AMENDMENTS TO THE DRAWINGS

This communication is a full and timely response to the non-final Office Action dated March 23, 2005. By this communication, the specification, Fig. 2, and claims 1 and 2 have been amended, and Figure 2B has been added.

Application No.: 10/679,421
(80408-0008)

Docket No.: TOC-0008

FIG. 2A

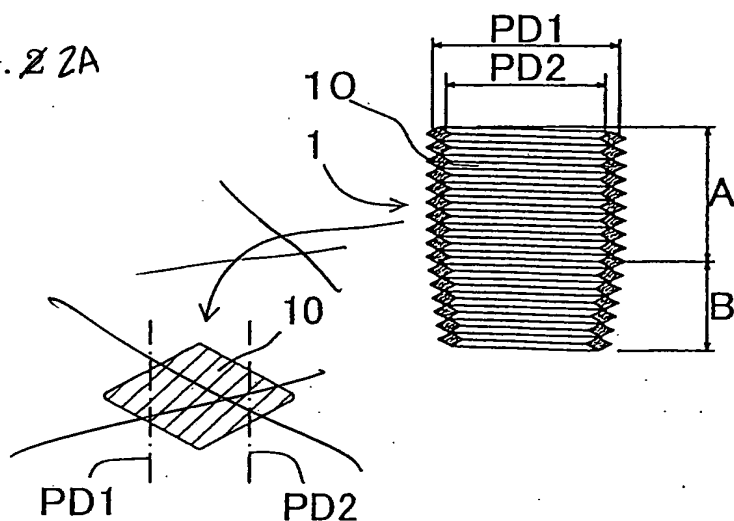
Sheet 1: Please amend Figure 2 by changing the figure designation to Figure 2A and removing the cross sectional view of element 10 as shown.

Sheet 1: Please add new Figure 2B that illustrates the cross sectional view of element 10 previously included in Figure 2 as shown.

In the drawings, Fig. 2 has been amended to remove the section view of element 10, and Fig. 2 has been newly designated as Fig. 2A. Fig. 2B has been added to include the sectional view previously included in Fig. 2. No new matter has been added.

Fig. 2 of the drawings was objected to for improperly showing a cross sectional view of element 10. As discussed above, Applicant has newly designated Fig. 2 as Fig. 2A and removed the cross-sectional view of element 10. Moreover, Applicant has added Fig. 2B, which includes the cross-sectional view of element 10 previously shown in Fig. 2. Accordingly, Applicant respectfully requests that the objections to the drawings be withdrawn.
